OREGON DEPARTMENT OF TRANSPORTATION GRANTS PASS INTERCHANGE EXIT 58 ROAD SAFETY AUDIT

N. 6th Street at NW Morgan Lane Mile Point -2.54 to -2.36

January 2013

Road Safety Audit Report

Exhibit 9 Example of 4-section signal heads

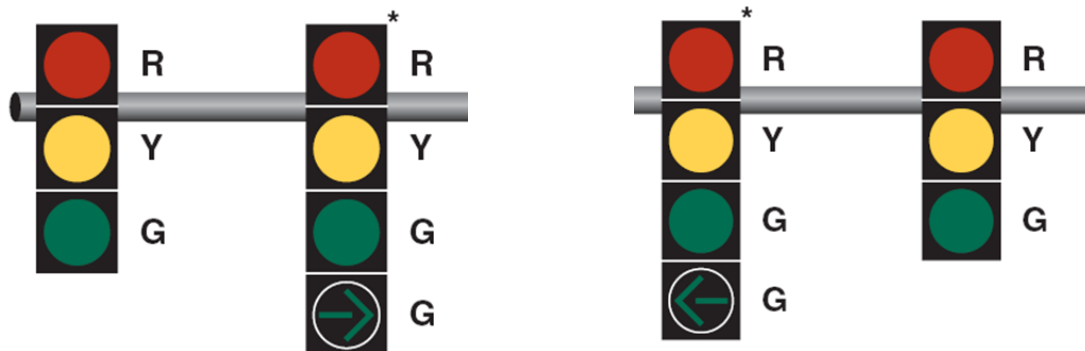
- Install retro-reflective back plates on signal heads to increase visibility of signals.
 - Add 1- to 3-inch-wide reflective strip around backplates (option added to 2009 Manual on Uniform Traffic Control Devices [MUTCD]) – see Exhibit 7 and Exhibit 8
- Review number, size, and location of signal heads and compare to MUTCD and ODOT “Traffic Signal Policy and Guidelines”
- Change signal indications
 - Change the signal indications for the inside lanes of the I-5 southbound ramp and NE Scoville Road to 4-section heads that include green arrows for the right- and left-turns. See Exhibit 9.

Exhibit 11 Restripe Scoville Road

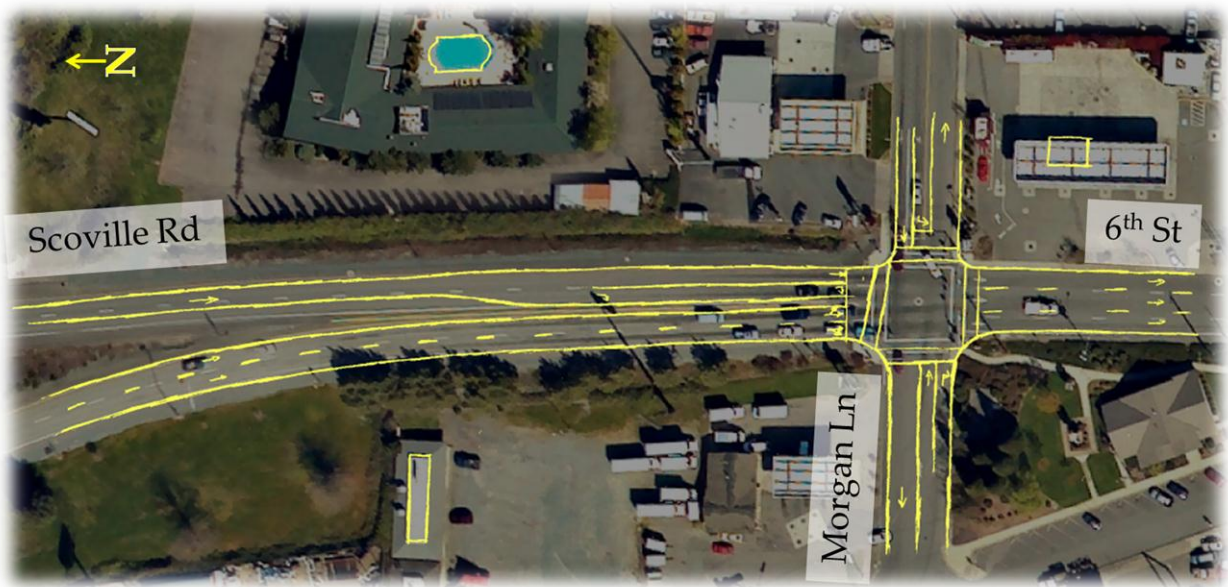
- Restripe NE Scoville Road to one through lane and one exclusive right-turn lane (See Exhibit 11).
 - Physically separates the traffic movements.
 - Allows for a right-turn arrow signal indication, which may reduce confusion for through vehicles mistaking the adjacent signal indication.

Exhibit 12 Existing separation between southbound approach legs

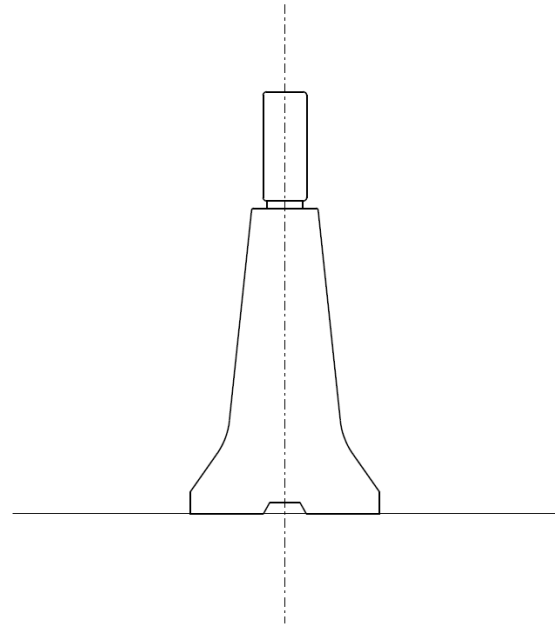
- Enhanced traffic separators
 - Construct 42-inch concrete barrier with 16-inch glare shields (see Exhibit 12 and Exhibit 13).
 - Provides physical separation and screening between the adjacent traffic movements. Increases the feeling of two separate and conflicting roadways.

Exhibit 16 Add new signal upstream, create two 2-phase signals

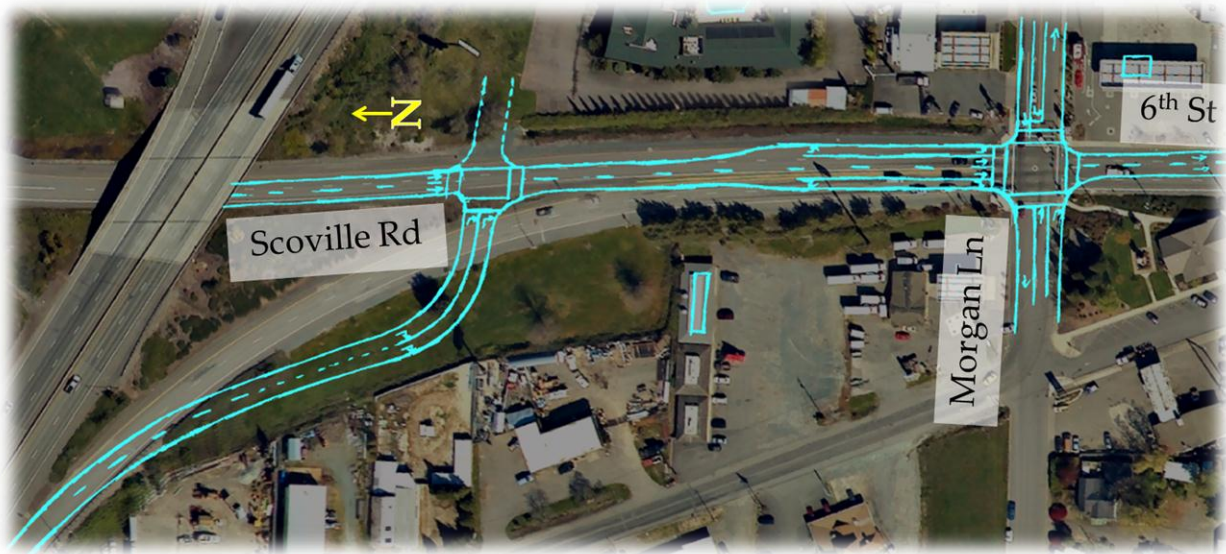
- Introduce a new signalized intersection and modify to two 2-phase signals (see Exhibit 16)
 - Realign and re-grade I-5 off-ramp, and re-grade NE Scoville Road.
 - Improves system hierarchy and simplifies the existing N 6th Street/NW Morgan Lane signal operations.

Exhibit 17 Phase 1 of Potential Future Interchange Improvement Plan

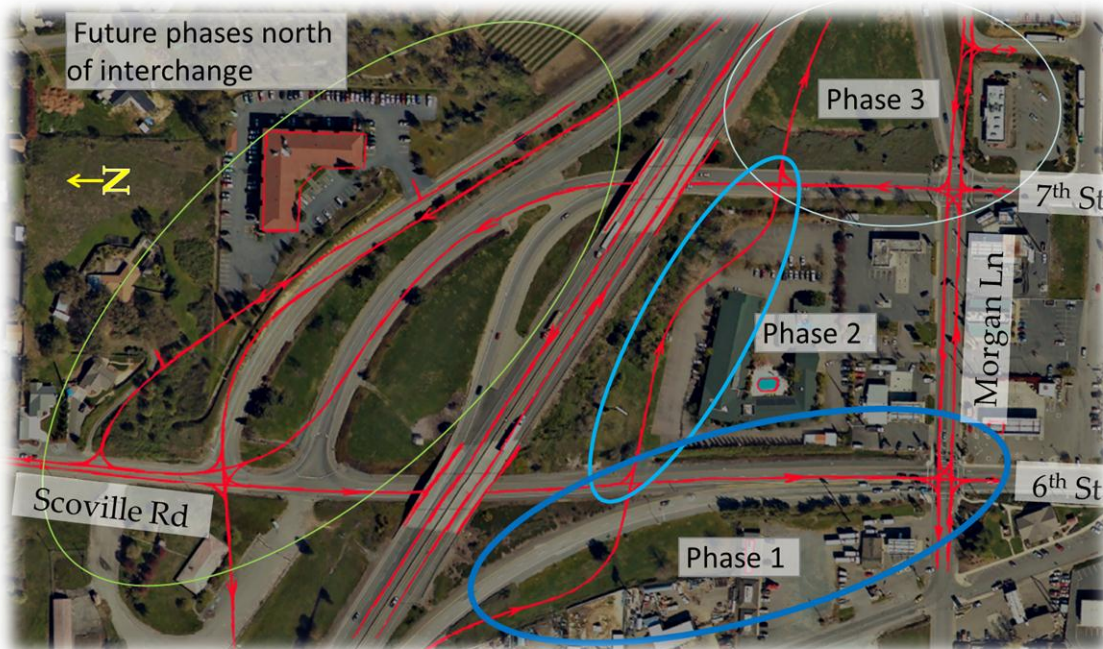
- Phase 1 of Potential Future Interchange Improvement Plan
 - Improvements shown in Exhibit 17 could be built as Phase 1 of a larger future interchange improvement plan, minimizing project throw-away.

Exhibit 22 Increase curb radii and restripe downstream to two lanes

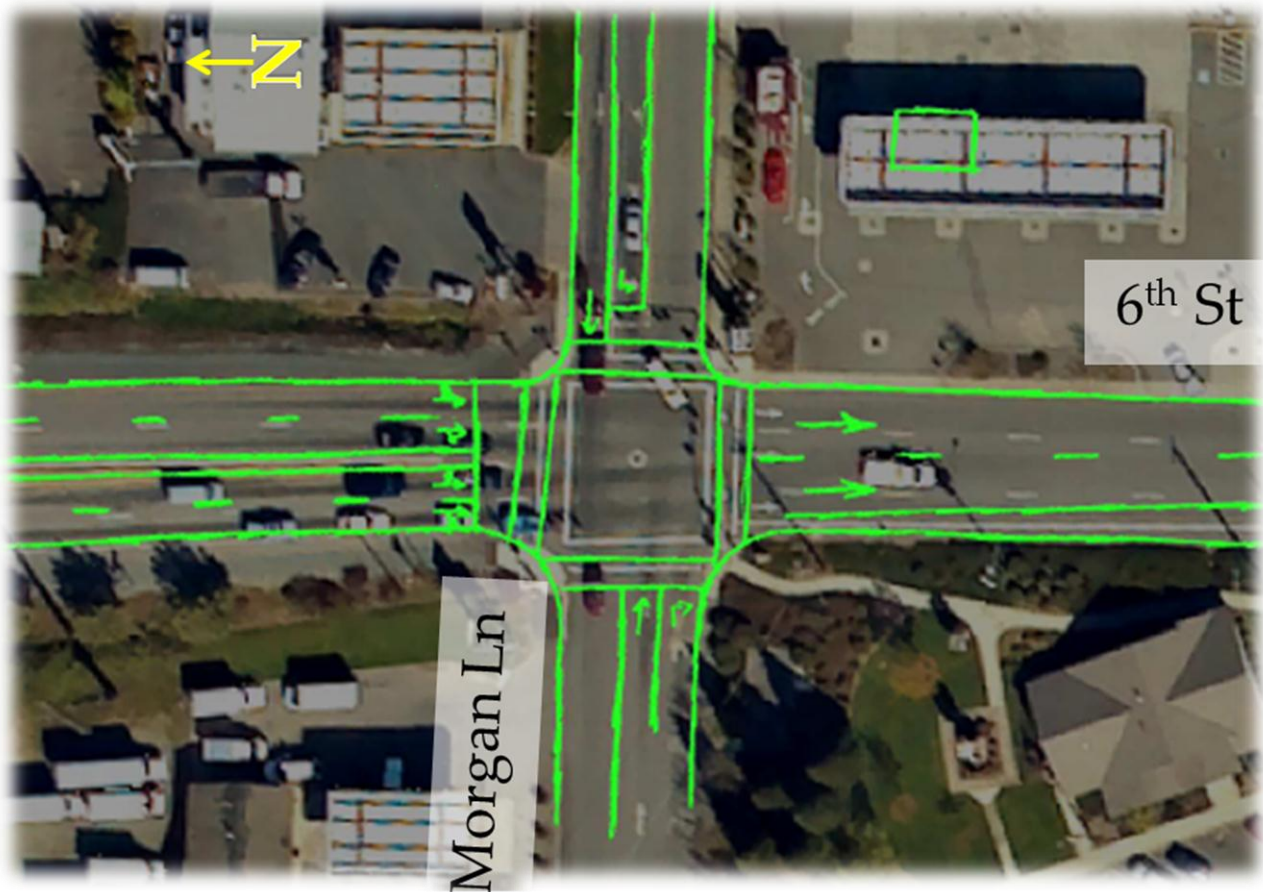
- Consider providing a protected left-turn phase for the westbound left-turn from NW Morgan Lane
 - This would add an additional phase and could contribute to additional delay at the intersection.
 - Alternatively, provide a protected-permissive left-turn phase with a flashing yellow arrow. Install signal heads with arrows for left-turns on westbound NW Morgan Lane.
- Improve turning maneuvers by increasing curb return radii (see Exhibit 22)
- Consider reducing N 6th Street just downstream of intersection to two lanes (see Exhibit 22)
 - Transition to three lanes beyond Vine Street intersection.
- Consider moving the I-5 southbound ramp stop bar back from the intersection to increase sight distance for vehicles turning right from eastbound Morgan Lane

Exhibit 34 Lane use signage – Restripe Scoville Road to through and exclusive right

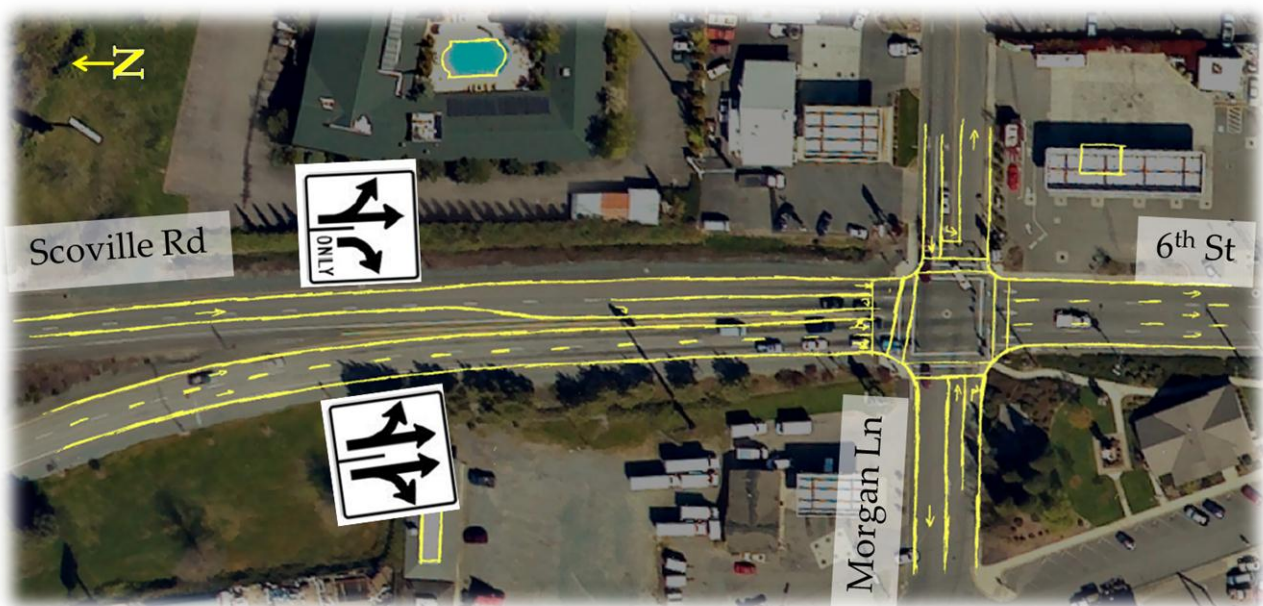
- Prioritize signage to relay the most important information
 - Regulatory
 - Warning
 - Informational and guide signing
- Considerations (apply to all recommendations):
 - Add lane designation signage prior to intersection (See Exhibit 34 through Exhibit 36)
 - Reduce signage on mast arms
 - Move Oregon Travel Experience (OTE) signs back on off-ramp
 - Combine City of Grants Pass entry and population signs (3 signs into 1)
 - Upgrade sign sheeting to High Intensity Prismatic (HIP)
 - Provide appropriate sign spacing per the MUTCD

Exhibit 40 Intersection reconfiguration to accommodate large trucks

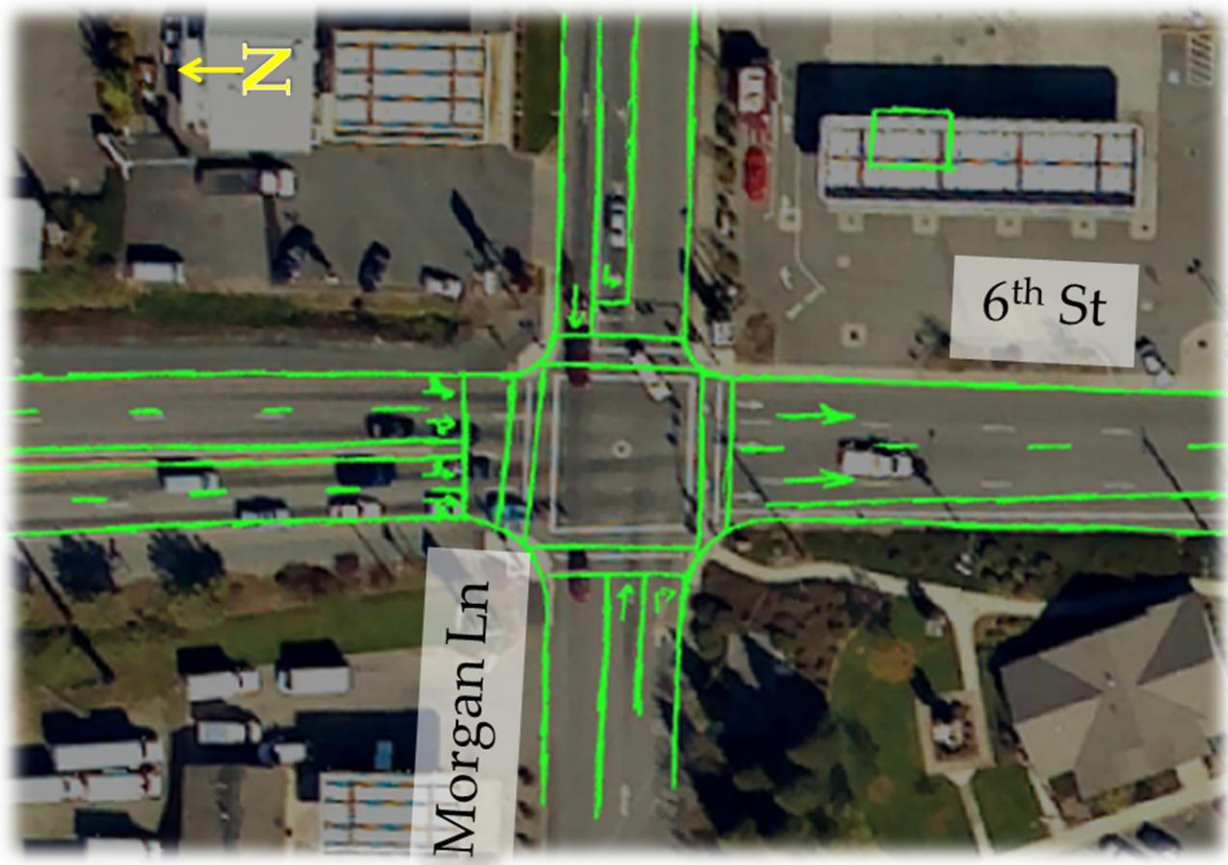
- Improve curb-return radii for NW Morgan Lane to N 6th Street movements to accommodate truck maneuvers
- Improve curb-return radii for the I-5 southbound ramp to NW Morgan Lane westbound movement to accommodate truck maneuvers

- Consider reducing downstream N 6th Street to two receiving lanes
- Move stop bar back for southbound approaches
